Access Compliance Report Public Rights-of-Way (Pedestrian Signals)

Main Street: ORANGEWOOD_AVE Cross Street: ORANGEWOOD_AVE Location: N

ADA ID: SGRK210928115537 Signal Type: Two Push Buttons-Non APS Overall Compliance: No Severity Scores: BTN 1: 60 BTN 2: 60 No BTN: N/A

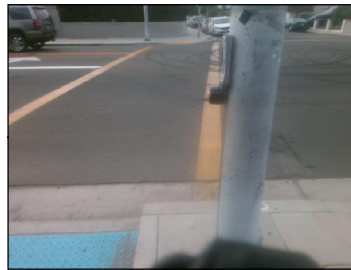
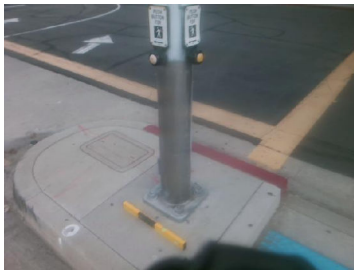
Compliance	Description	Data	Compliance	Description	Data
	Button Count	Button2	N/A	Distant to Additional Button (in)	N/A
	Additional Button Present?	No	N/A	Additional Button ID	N/A
	Located In An Island/Median?	Yes			
N/A	B 1 Sign Present?	Yes	N/A	B 2 Sign Present?	Yes
Yes	B 1 Sign Purpose?	Yes	Yes	B 2 Sign Purpose?	Yes
Yes	B 1 Sign Lettering & Contrast?	Yes	Yes	B 2 Sign Lettering & Contrast?	Yes
Yes	B 1 Parallel To XWalk?	Yes	Yes	B 2 Parallel To XWalk?	Yes
N/A	B 1 PAR to Button?	N/A	N/A	B 2 PAR to Button?	N/A
N/A	B 1 PAR to XWalk?	N/A	N/A	B 2 PAR to XWalk?	N/A
No	B 1 Clear Floor Space?	Yes	No	B 2 Clear Floor Space?	Yes
N/A	B 1 FWD Approach?	N/A	N/A	B 2 FWD Approach?	N/A
N/A	B 1 FWD Approach Constrained?	No	N/A	B 2 FWD Approach Constrained?	No
No	B 1 FWD Approach Reach (in)	30	No	B 2 FWD Approach Reach (in)	25
N/A	B 1 FWD Approach Width (in)	N/A	N/A	B 2 FWD Approach Width (in)	N/A
N/A	B 1 FWD Approach Obstruction?	Yes	N/A	B 2 FWD Approach Obstruction?	No

N/A	B 1 FWD Approach Obstruction Dist (in)	30	N/A	B 2 FWD Approach ObstructionDist (in)	N/A
N/A	B 1 PARA Approach?	N/A	N/A	B 2 PARA Approach?	N/A
N/A	B 1 PARA Approach Constrained?	N/A	N/A	B 2 PARA Approach Constrained?	N/A
N/A	B 1 PARA Approach Reach (in)	N/A	N/A	B 2 PARA Approach Reach (in)	N/A
N/A	B 1 PARA Approach Width (in)	N/A	N/A	B 2 PARA Approach Width (in)	N/A
N/A	B 1 PARA Approach Obstruction?	N/A	N/A	B 2 PARA Approach Obstruction?	N/A
N/A	B 1 PARA Approach Obstruction Dist (in)	N/A	N/A	B 2 PARA Approach Obstruction Dist (in)	N/A
Yes	B 1 Clear Floor Space Slope (%)	2.4	Yes	B 2 Clear Floor Space Slope (%)	1.7
No	B 1 Clear Floor Space XSlope (%)	5.2	No	B 2 Clear Floor Space XSlope (%)	5.1
N/A	B 1 PAR Slope (%)	3.2	N/A	B 2 PAR Slope (%)	4.7
Yes	B 1 Height (in)	47	Yes	B 2 Height (in)	47
Yes	B 1 Pressure (#)	5	Yes	B 2 Pressure (#)	5
Yes	B 1 Closed Fist Operation?	Yes	Yes	B 2 Closed Fist Operation?	Yes

Possible Solutions: Replace Signal Push Button With APS Button. Remove & Relocate Sign. Remove and Replace Clear Space.
